PROJECT: Ferndale Terrace Project

City Project SW2016-01; TIB Project Number 8-2-985(011)-1

ADDENDUM NO. 1
To the Contract Documents for:
City of Ferndale, Washington
FERNDALE TERRACE PROJECT
City of Ferndale Project No. SW2016-01; TIB Project Number 8-2-985(011)-1

**FERNDALE TERRACE PROJECT
VISTA DRIVE TO HENDRICKSON AVENUE
PROPOSED CNQ RELOCATION PLAN - STA 10+00 TO 20+50**

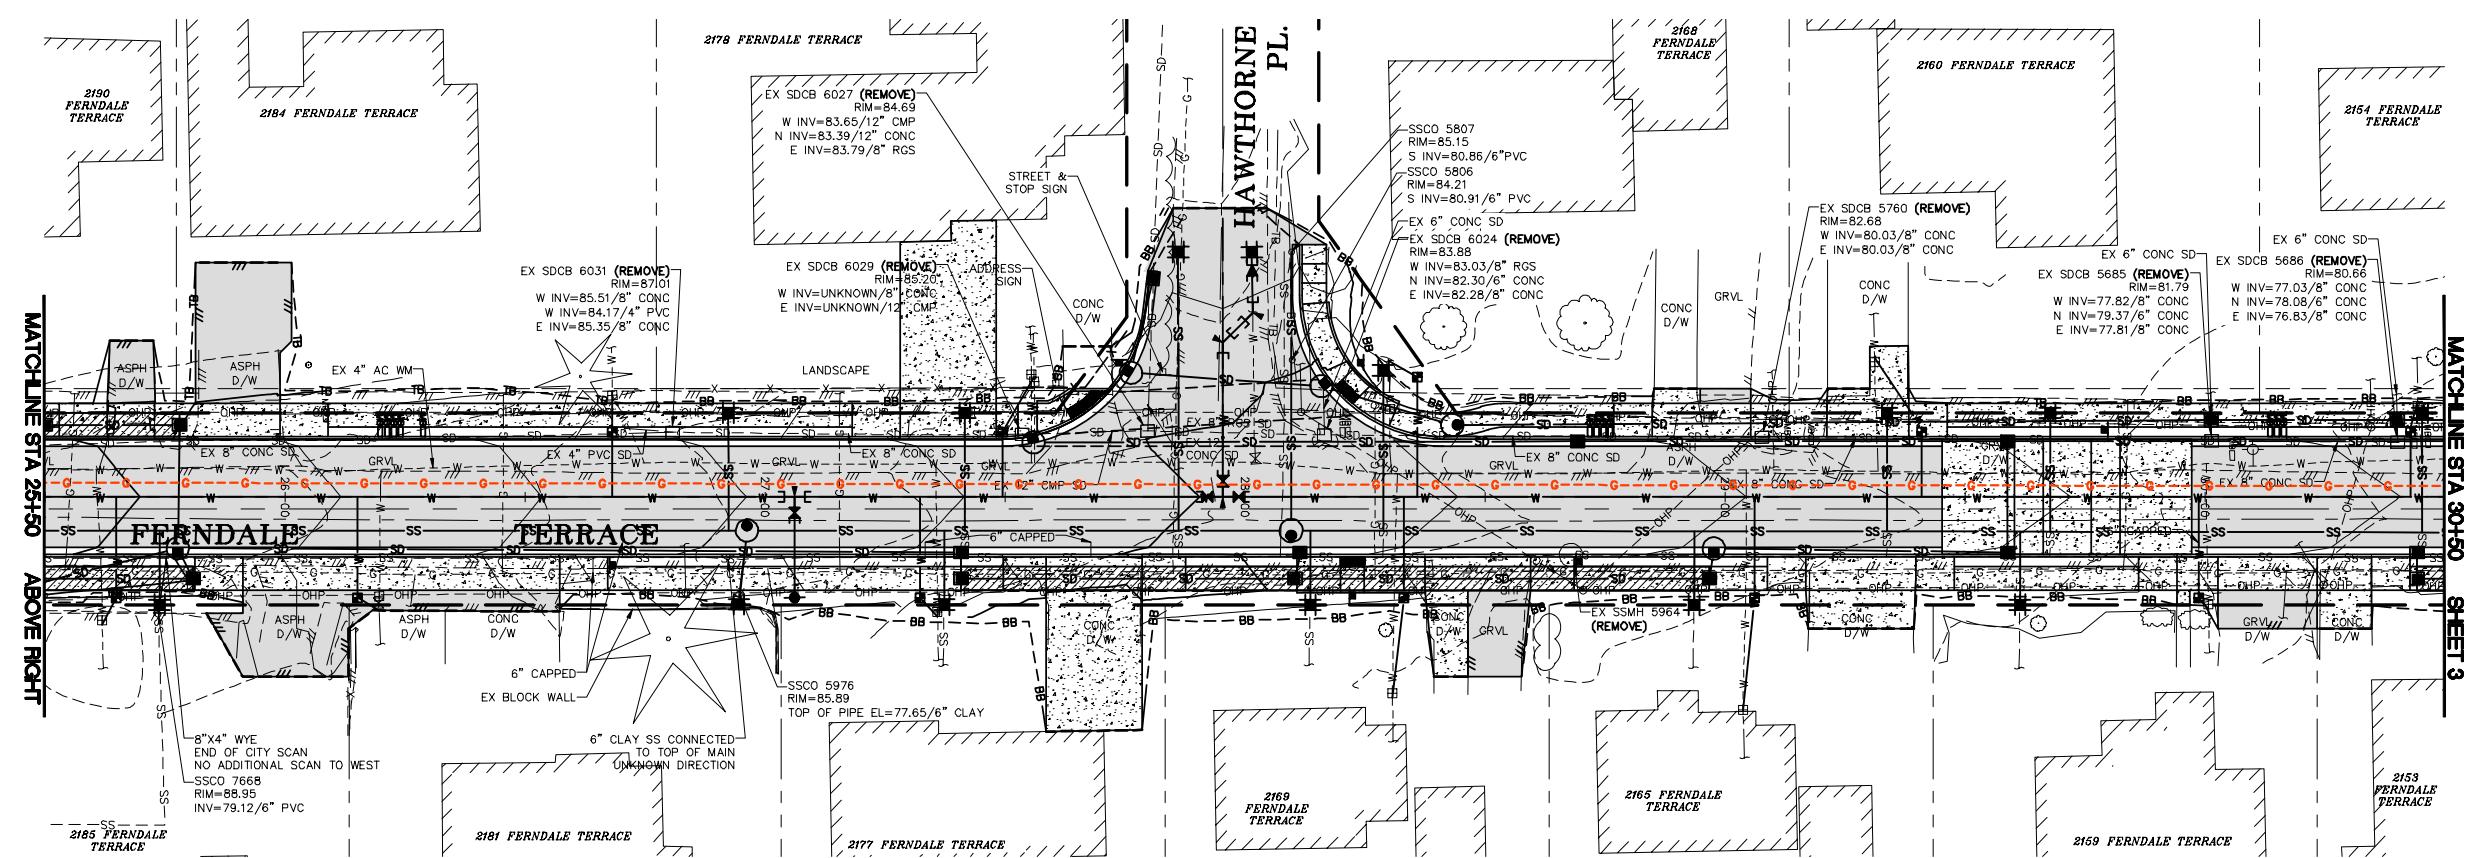
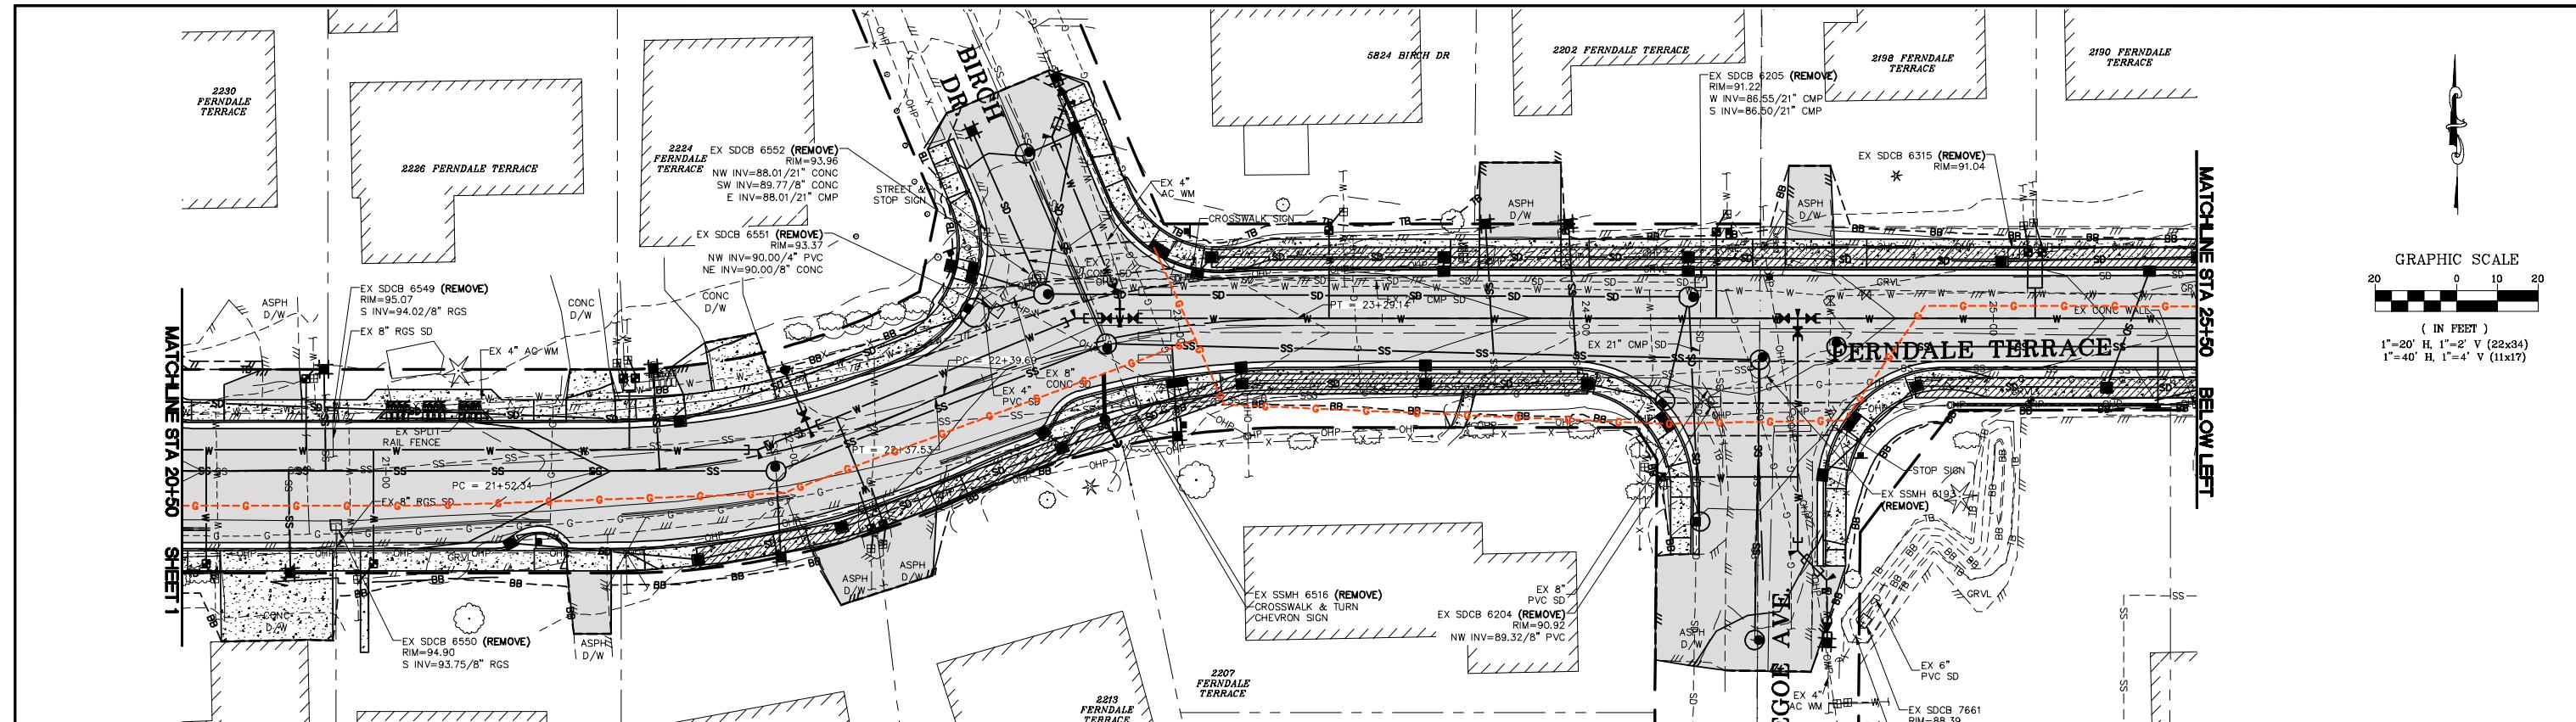
plans be relocated to facilitate the construction of this contract? **Per WSDOT Standard Specifications and RCWs noted in the WSDOT Standard Specifications, the utilities are marked with "...reasonably accurate information...". Given this, the Engineer may request potholing prior to making any connection to determine the actual location of the sanitary sewer or gas main. Additional Cascade Natural Gas (CNG) relocation information is included in CNG relocation sheets included with this addendum.**

NOTE:
 1. RELOCATION TO OCCUR PRIOR TO START OF CITY WORK.
 2. LOCATION OF RELOCATED GAS MAIN IS APPROXIMATE.
 3. CITY TO OBTAIN AS-BUILT INFORMATION.
 4. CONTRACTOR TO VERIFY AS-BUILT LOCATION OF GAS AS NECESSARY TO PROCEED WITH WORK.
